## Accessibility Survey

### Town of Tisbury Library

200 Main Street  
Vineyard Haven, MA 02568

Date of Inspection  
4/30/2019

#### Path Next to Patio

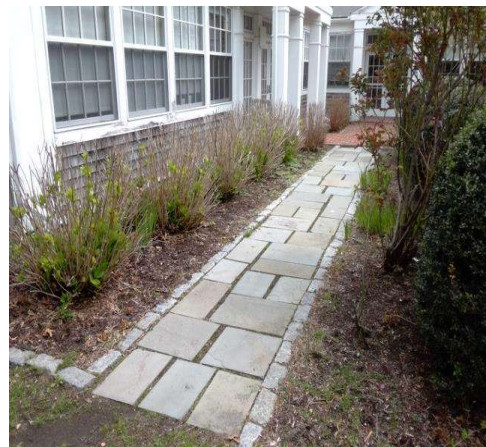
The surface of the primary accessible path of travel is rough and uneven, providing a hazardous surface for individuals with mobility impairments and the general public.

Resurface the path of travel to provide a smooth, firm, stable and slip-resistant surface.

#### Backyard Patio Gate

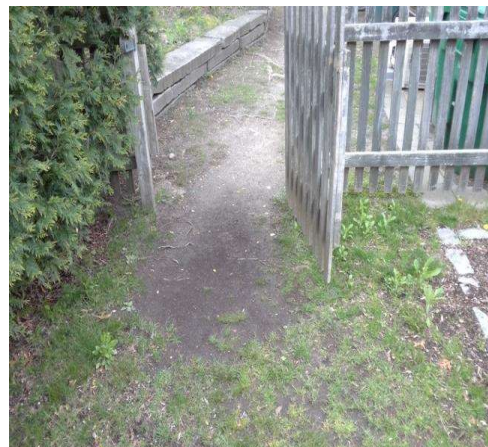
There is less than the required latch side clearance on the pull side of the door.

Provide required latch side clearance on the pull side of the door.

Recommendation At least 18.00 inches

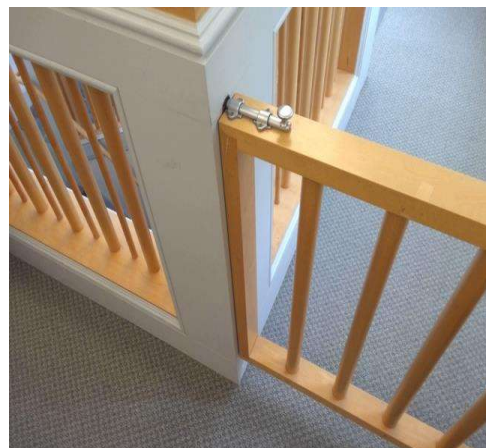
The bottom of the door does not provide a smooth, uninterrupted surface, or panel to allow the door to be opened by a wheelchair footrest without creating a trap or hazardous condition.

Install a panel or replace the door to provide a smooth, uninterrupted surface at the bottom of the door.

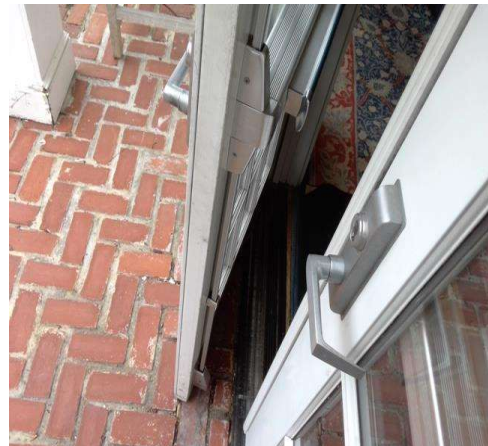
The bottom of the door does not provide a smooth, uninterrupted surface, or panel to allow the door to be opened by a wheelchair footrest without creating a trap or hazardous condition.

Install a panel or replace the door to provide a smooth, uninterrupted surface at the bottom of the door.

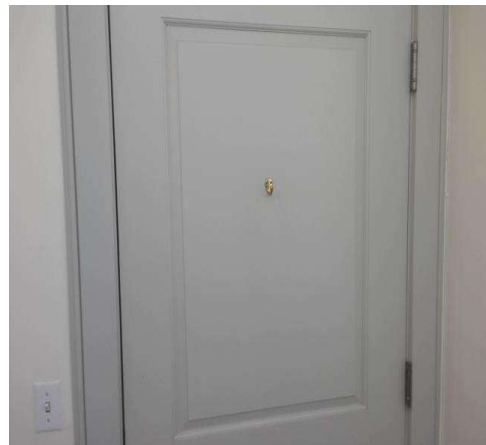
The coat hook is not mounted at the correct height.

Mount the coat hook at the recommended height.

Recommendation 15.00 - 48.00 inches
